MEMORANDUM

Re: Riverside Mixed Use Development Design

Illustration from "06.09.11 Community Meeting Update: Presentation" by BH Normandy

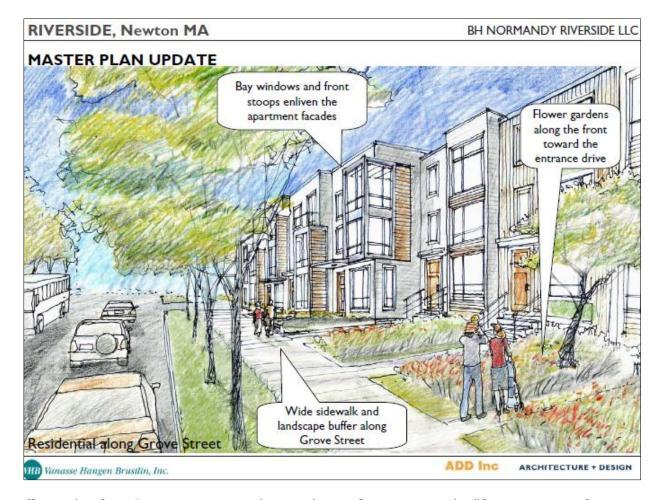
On the following page is an image from a 2011 presentation by the developer to a community meeting on the BH Normandy proposal. It struck me then and strikes me now as exemplifying the implementation of the intent of the City in its November 2011 adoption of the Mixed Use Centers amendment to the *Newton Comprehensive Plan*. One paragraph from that *Plan* (on the following page) clearly articulates the importance of building orientation as a means of integrating new development with its context, a basic intention of this City's support for such complexes. The Riverside design has moved away from the illustrated image through a series of steps, as I understand culminating in a design offering no direct access between the residential building and Grove Street.
